NRC Public Meeting on NTTF 2.1 Seismic and Appendix H to NEI 12-06

Update on Appendix H to NEI 12-06

Path 4 NRC Comment Responses

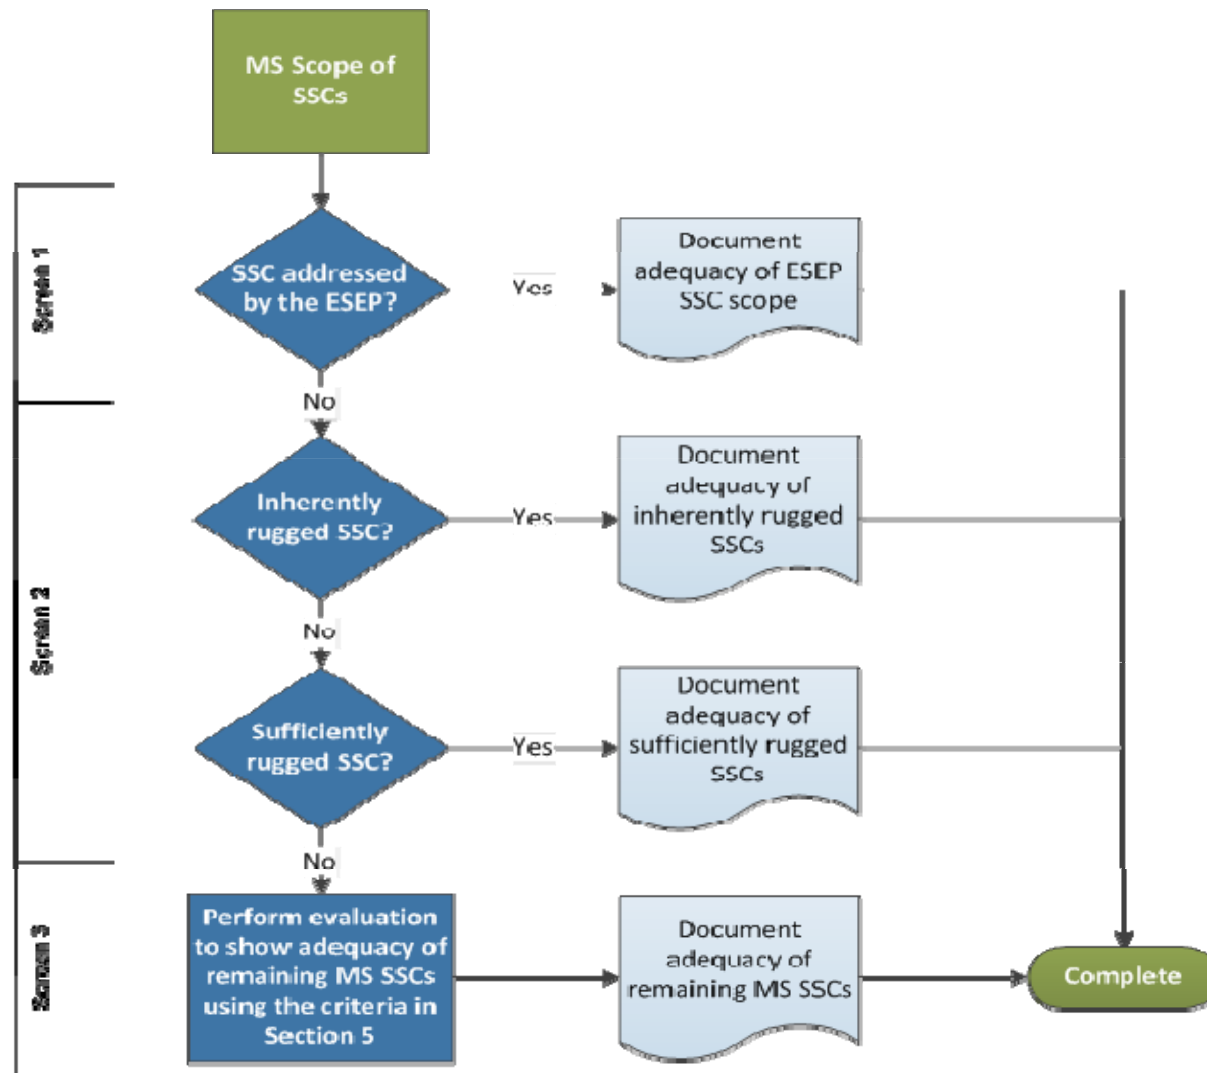
Comment 24. Page 8, third sentence under “Basis:” It is important to point out the limitations of the ESEP and why it was done to provide an overall context for the scope of this evaluation. The ESEP was developed as an interim evaluation so that more time taken to perform the SPRA. The scope of the ESEP was intentionally limited to meet expedited schedules. Therefore, these evaluations will have to address the omissions in the ESEP and supplement with new evaluations for SSCs and other aspects of mitigating strategies that have been not evaluated to the new seismic hazard.

- Discussion added “The ESEP was an interim evaluation and included a review for all potential failure modes with one exception associated with seismic interactions. The ESEP included the reviews of seismic interactions associated with block walls in the vicinity of the ESEP equipment and for differential displacement type interactions for tanks. As such, any additional seismic interaction failure modes affecting the ESEP equipment would need to be considered as part of the MSA. Outside of these additional seismic interaction reviews, no further work is required to demonstrate the reasonable protection to withstand the new seismic hazard for those SSCs that were within the scope of the ESEP.”
